REMARKS

VERSION WITH MARKINGS TO SHOW CHANGES MADE

Fig. 4

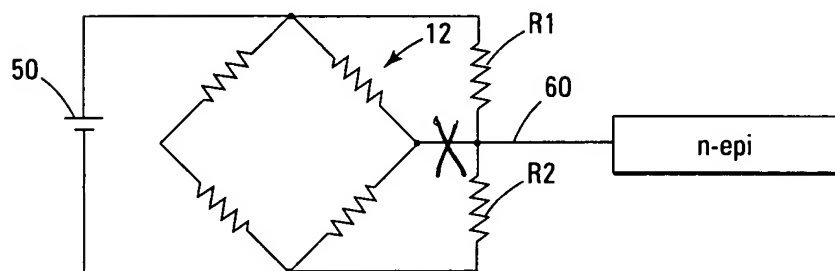
Upon review of the formal drawings filed March 1, 2002, a discrepancy between the drawing as filed and the formal drawing has been observed. The correction is marked in red on the enclosed FIG. 4, and a corrected substitute drawing is enclosed herewith, thereby bringing the recently submitted FIG. 4 into conformance with FIG. 4 as originally filed. Please acknowledge acceptance of corrected FIG. 4.
